FINAL ORDER

The after-the-fact Special Standards Request Form you submitted for owner: Collin Randall, Start Card number 1072134, is hereby approved for the following: You may construct this water supply well, placing a lower split seal in unconsolidated formations, as described on your Special Standards Request Form dated July 26, 2024. All other well construction standards apply as required under Oregon Administrative Rules 690-210. A copy of your Special Standards Request Form is enclosed.

REQUEST FOR WRITTEN APPROVAL TO USE CONSTRUCTION METHODS NOT INCLUDED IN OREGON ADMINISTRATIVE RULES 690-200 THROUGH 690-240

Well construction question for Permit G-16882

(15) Diagram showing the pertinent features of the proposed well design and construction (attach additional pages if need):

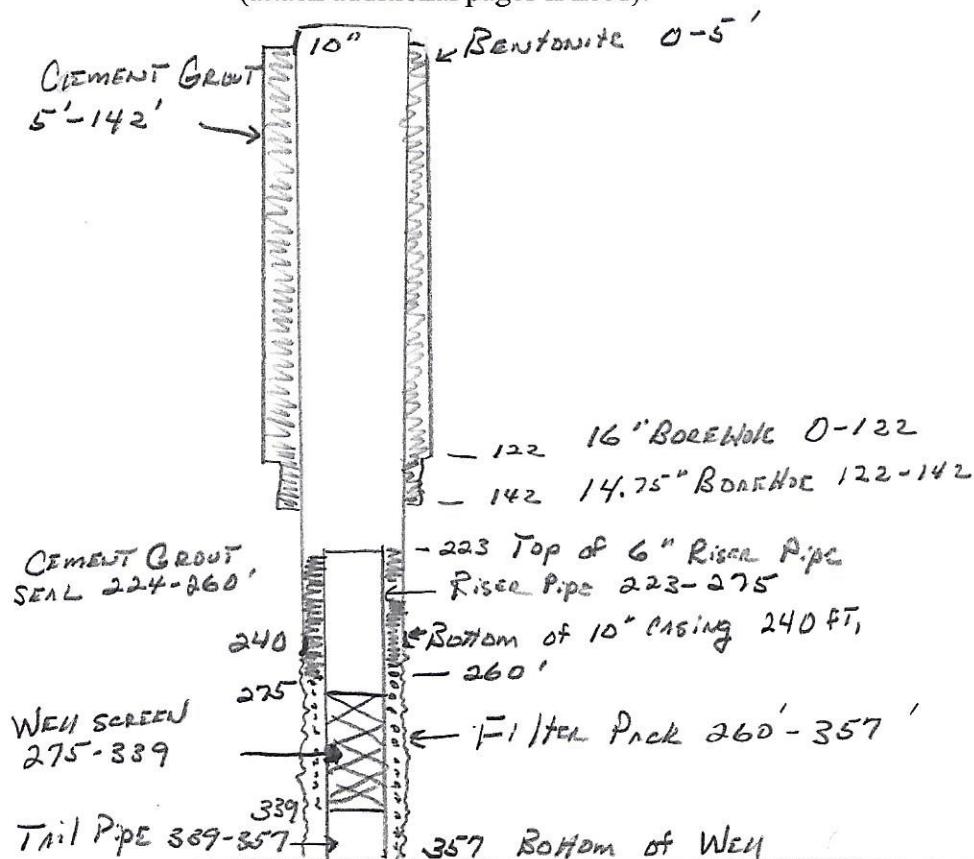
Need to install a lower casing seal around inner casing into alluvial formation

The upper alluvial formation from 207-240 had a swl of 40 ft & the lower alluvial formation had a

swl of 166 ft. We sealed thru the confining unit that was separating these two water bearing zones.
